## Toledo Planning Commission June 10, 2026

**DATE:** June 3, 2026  
**TO:** Toledo Planning Commission  
**FROM:** Justin Peterson, Contract Planner  
**RE:** SD-1-25 Final Plat Review

LEEWAY INDUSTRIAL SITES  
 FOR DEWEY & CAROL GOODELL  
 IN THE NE 1/4 OF SECTION 18  
 TOWNSHIP 11 SOUTH, RANGE 10 WEST, WM  
 IN TOLEDO, LINCOLN COUNTY, OREGON

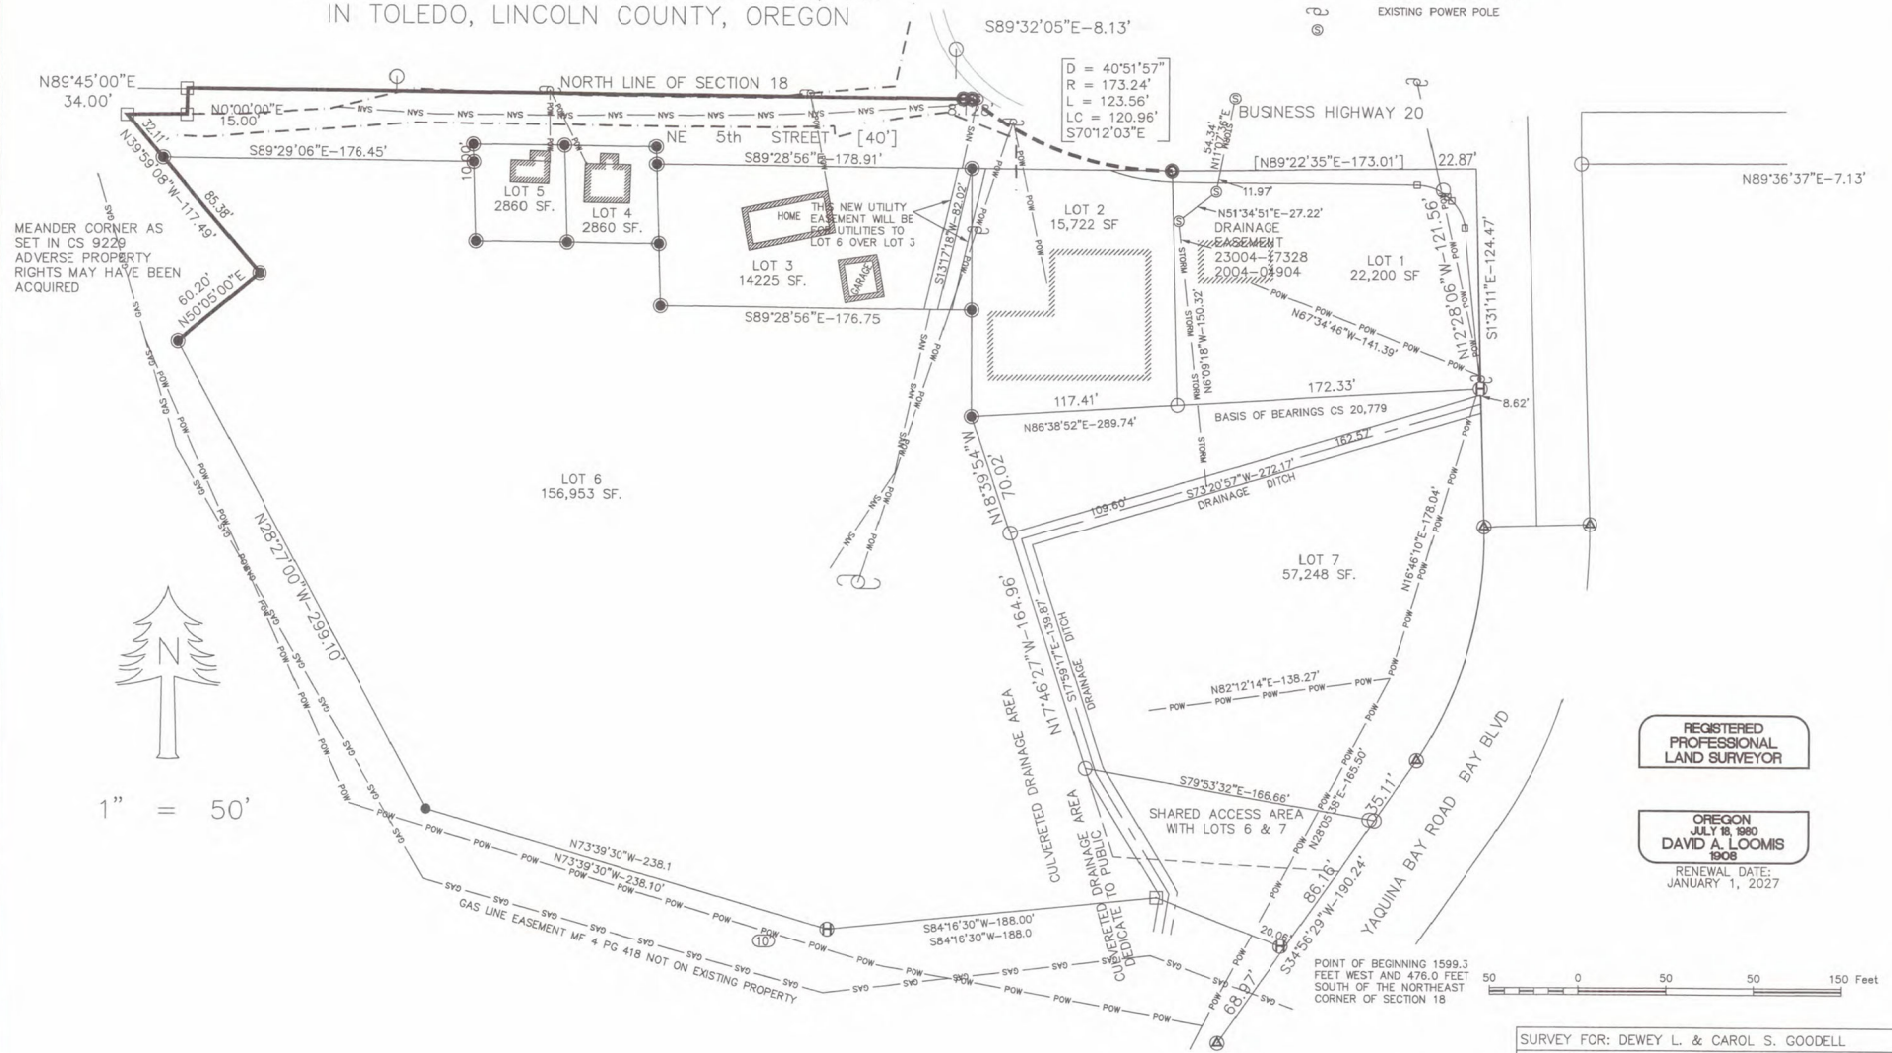
8.	<p>The entirety of the NW 5th Street dedication shall be from the Goodell property as indicated on the submitted plat and application.</p>	<p><b>OK – Applicant provided a “Special Note” on Page 5 of the plat. Applicant stated that the street is located on the Goodell side and pointed to historic survey CS5528.</b></p>

9.	<p>The recording of easements (in addition to being noted on the plat) as required and as appropriate by the Public Works Director to serve the interior properties for driveway access and utilities, including water and sewer, in accordance with the minimum width and other standards in the Public Infrastructure Design Standards Manual, before construction permits will be issued..</p>	<p><b>OK - PWD needs to review proposed easements as shown on plat and determine if widths meet Public Infrastructure design manual.</b></p>
